From: (b)(6)  
To: Murphy, Emmett  
Cc: Andersen, Isaac  
Subject: SONGS SG Update  
Date: Tuesday, February 21, 2012 4:25:35 PM

From: (b)(6)  
Sent: Thursday, February 23, 2012 4:50 PM  
To: Kalyanam, Kaly  
Cc: Murphy, Emmett; Karwowski, Kenneth; Kulesa, Gloria; Hall, Randy  
Subject: SONGS Steam Generator Drawings for 2/24 phone call

This call is a follow-up to the status call held on 2/6/2012. It will primarily focus on the licensee's inspections and testing of the U2 SG tubes. U3 SG activities may be mentioned, but will be discussed more fully in a future call.  
Attached are some preliminary responses from SCE regarding some of the NRC questions asked in the previous call on 2/6.

Debris Found on Top of TSP #4-2E088

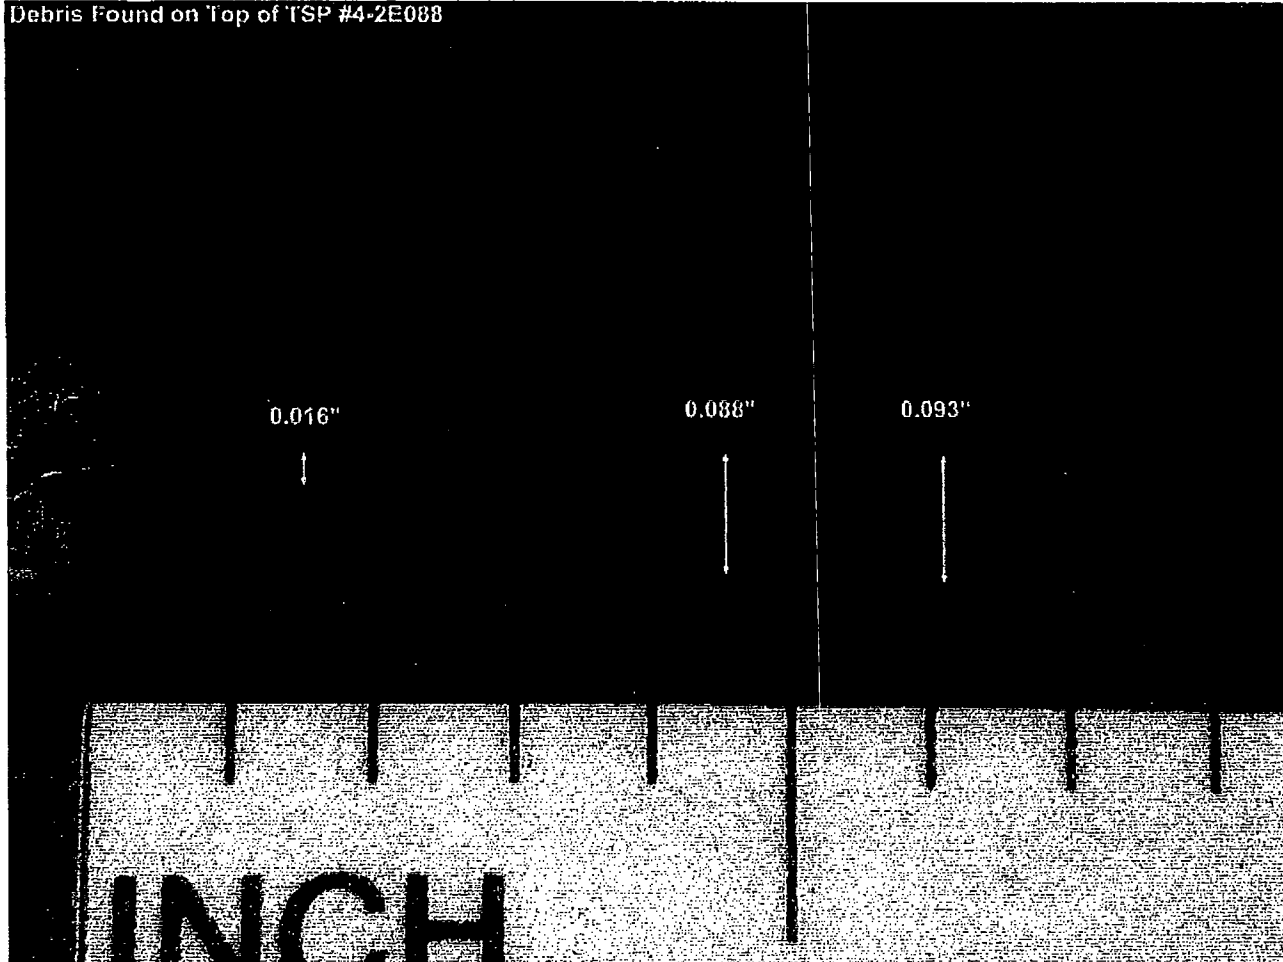
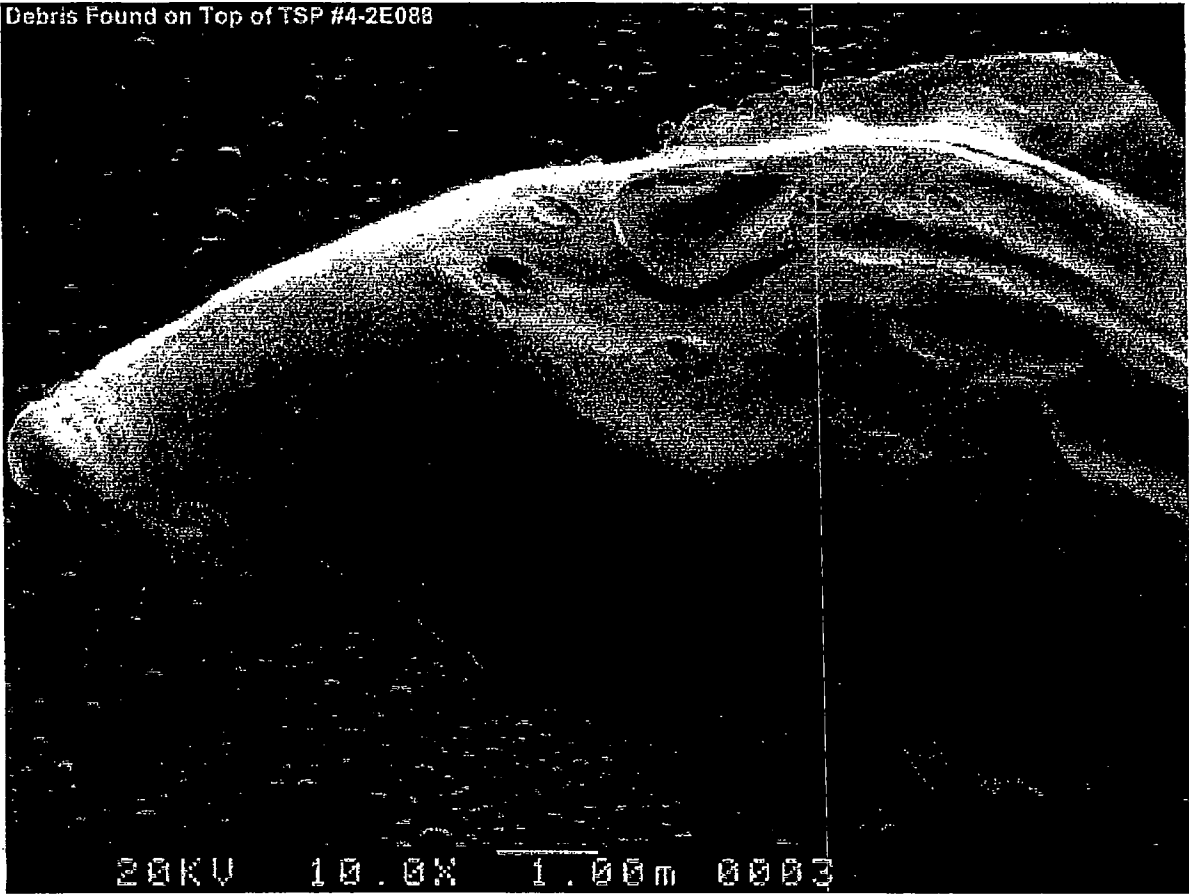
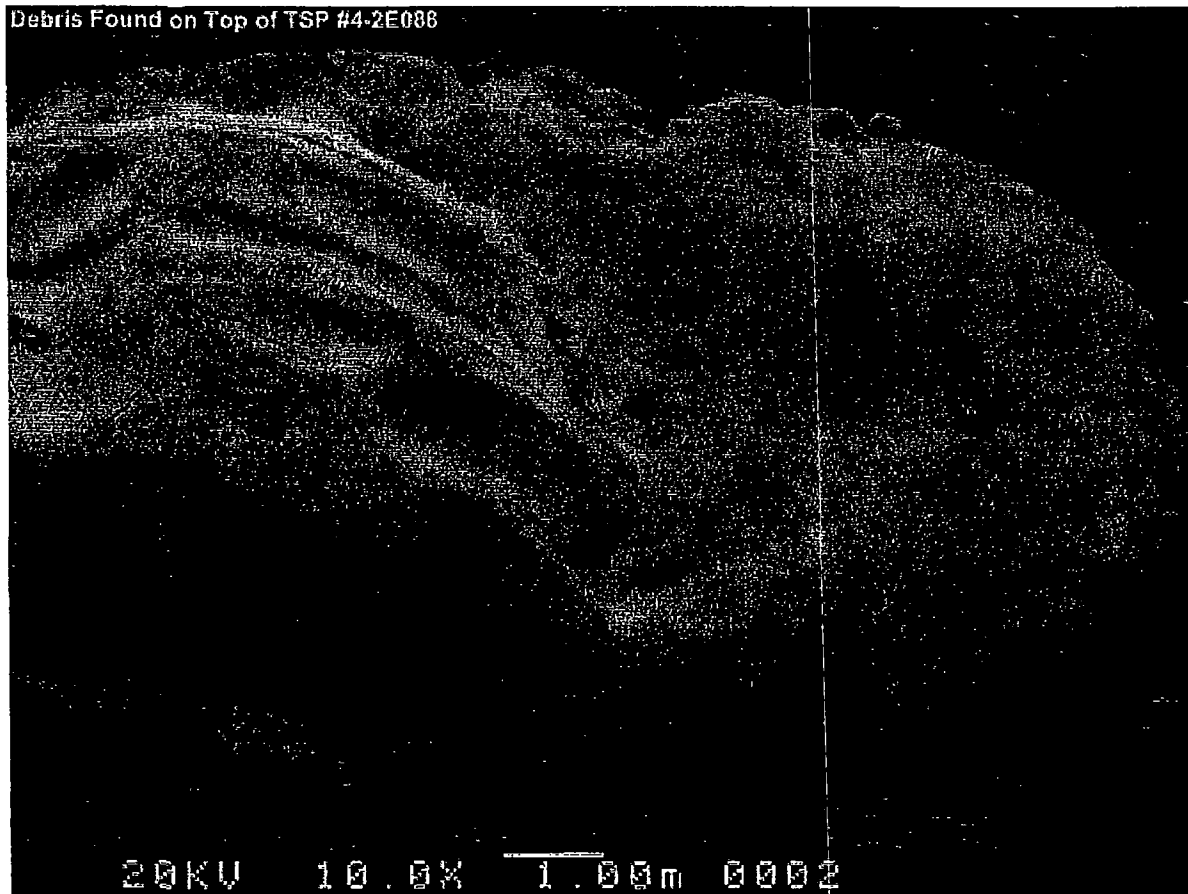
As mentioned in the voice message I left, if possible can you guys provide me with a copy of NN 201854749. This is the NN that documents the retrieval of the lose part in the SG in Unit 2.

The optical microscope examination revealed the debris as a weld metal of which a portion ( identified in the photos as Weld Metal #1) had flowed into a crevice and a rounded portion ( identified as Weld Metal #2). The nominal thickness of the Weld Metal #1 was measured as 0.016" and it tapers down at the extremities. The rounded section, which contained surface voids had a nominal thickness of 0.088". The next set of SEM photos show the surface details of the debris illustrating voids and mechanical rubbing.

Figure 2-4: SONGS-2&3 AVB Retainer Bar General Arrangement (overhead view)

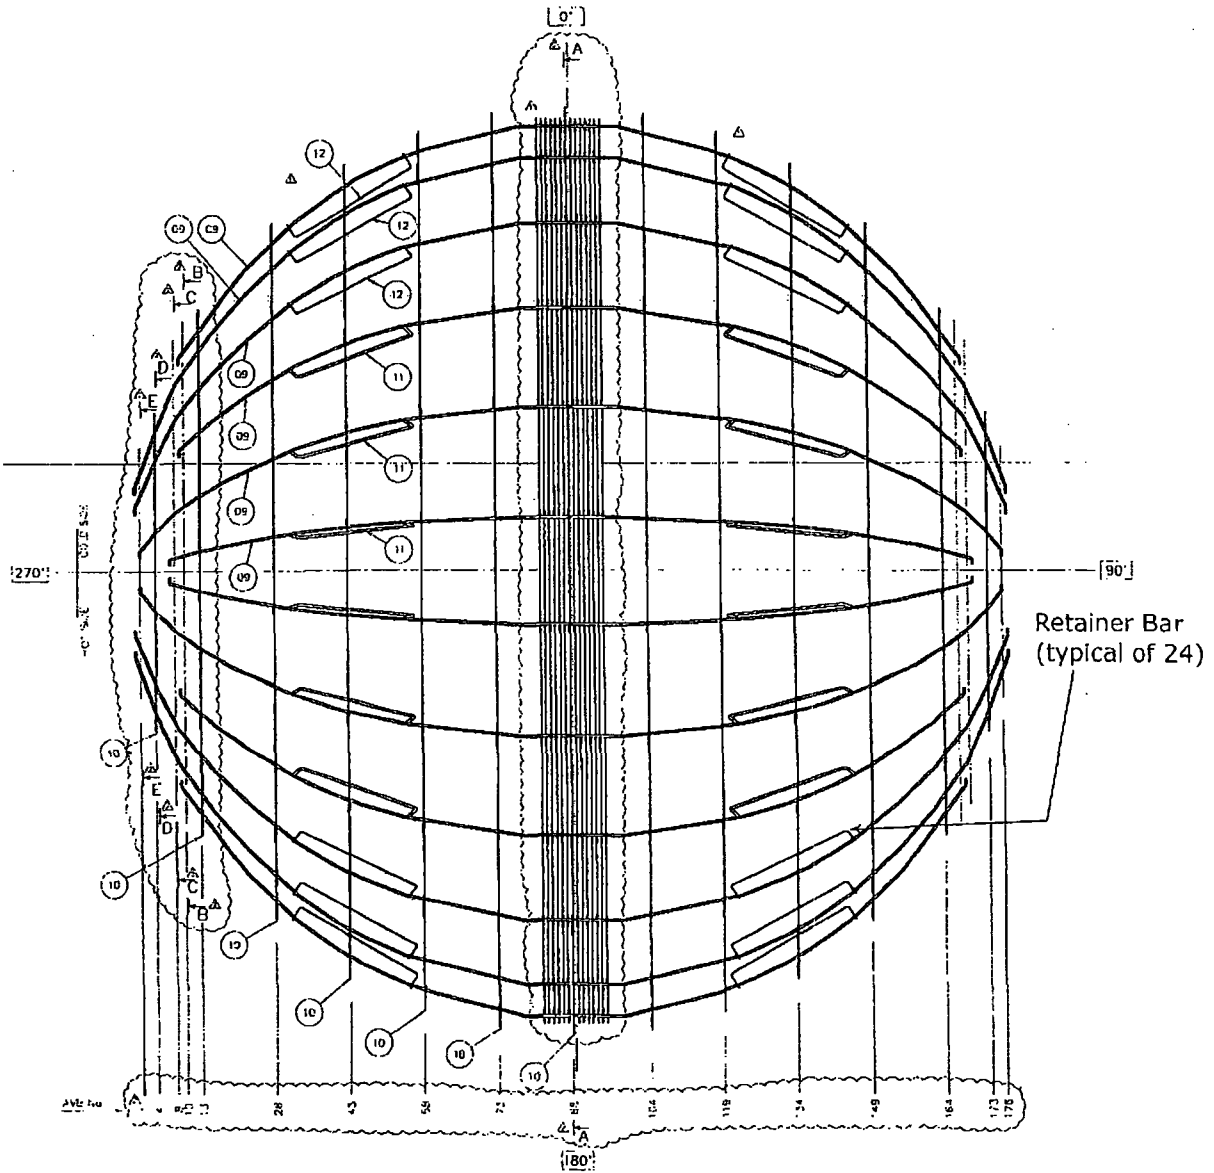
1. Provide sketches or drawings of the Anti Vibration Bar, Retaining Bar and the Retainer Bar.

Figure 7-2: Structural and Condition Monitoring Limit Curves for Wall Thinning at 820 psia Secondary Pressure

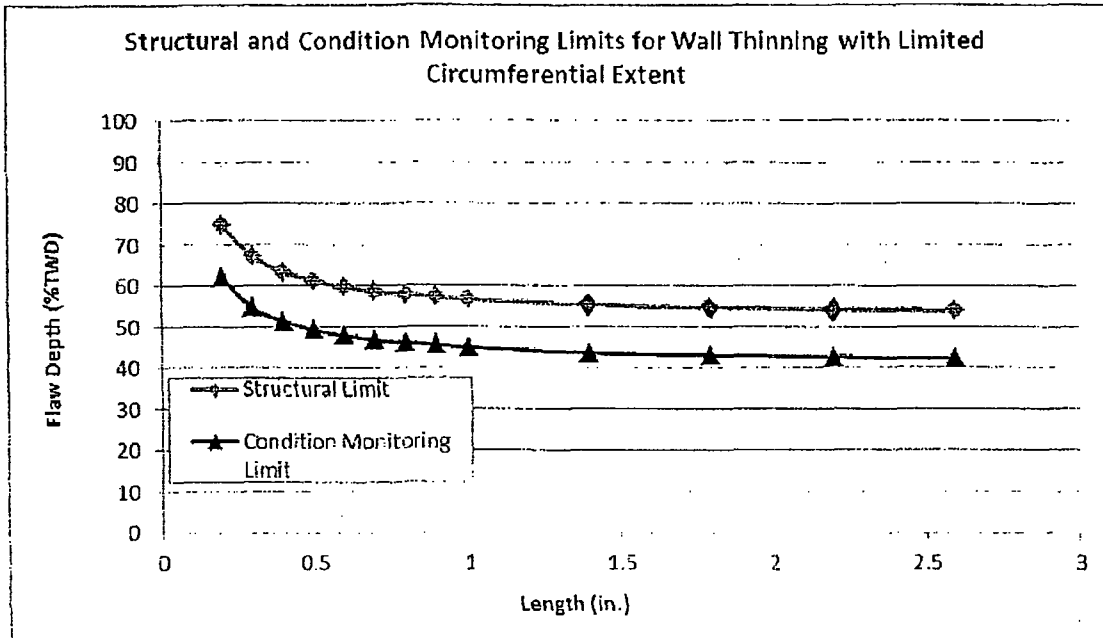
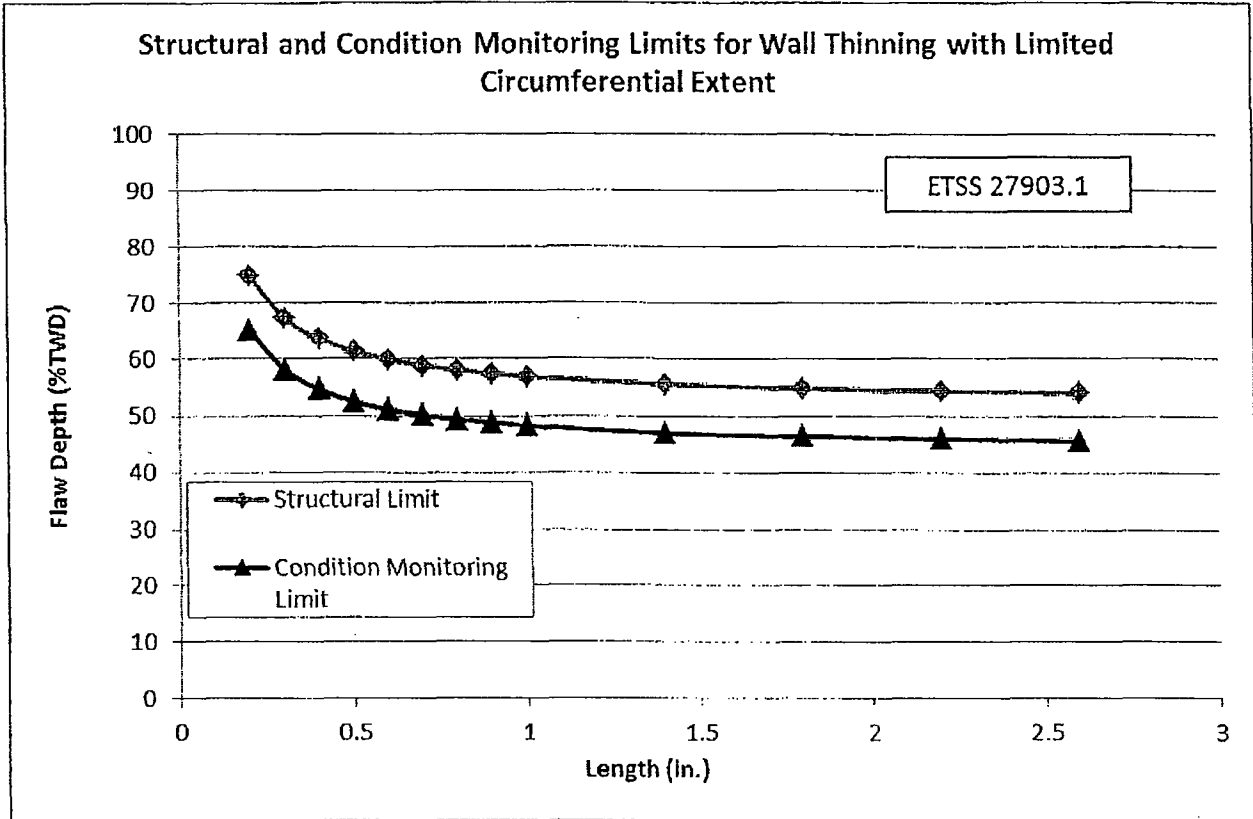
3. Provide condition monitoring structural limit curves.

## AVB and TSP Wear +Point™ Depth vs Bobbin Depth

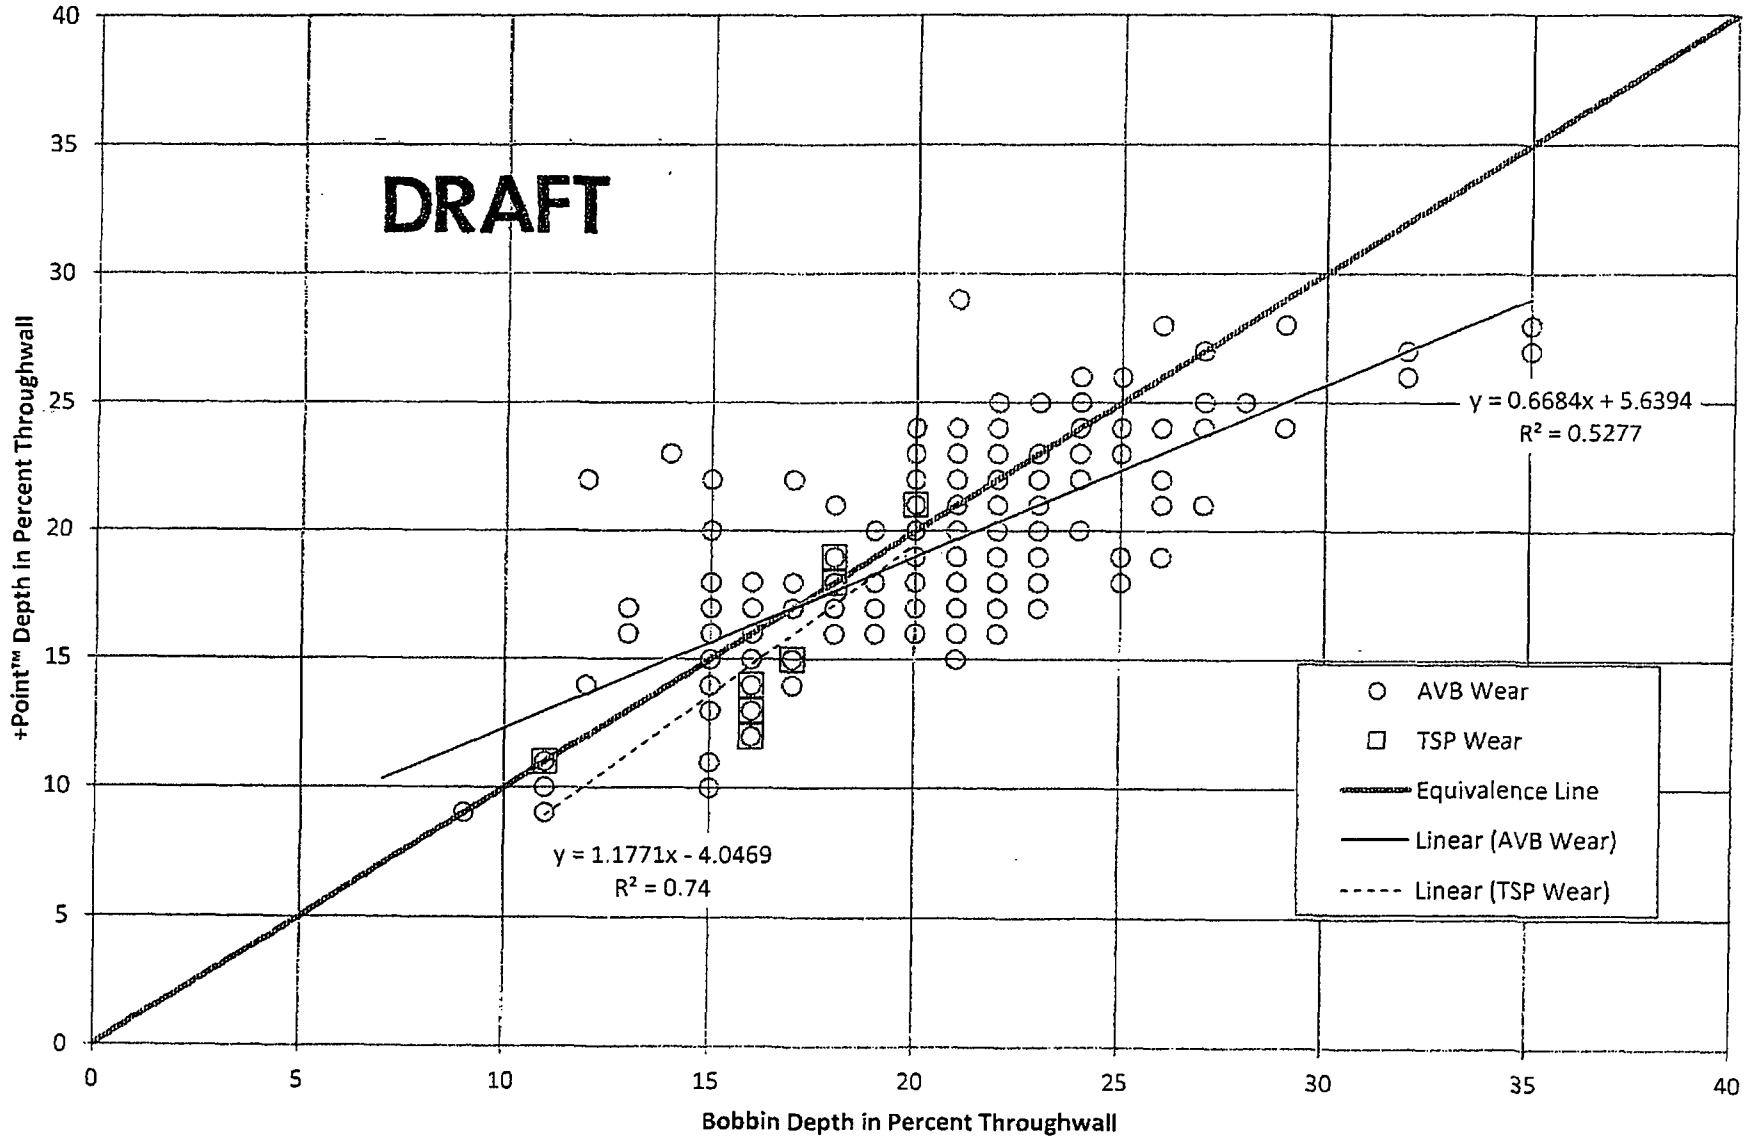
4. Provide info on the consistency between the tube wear results from the Bobbin ECT and the Rotating Probe results.
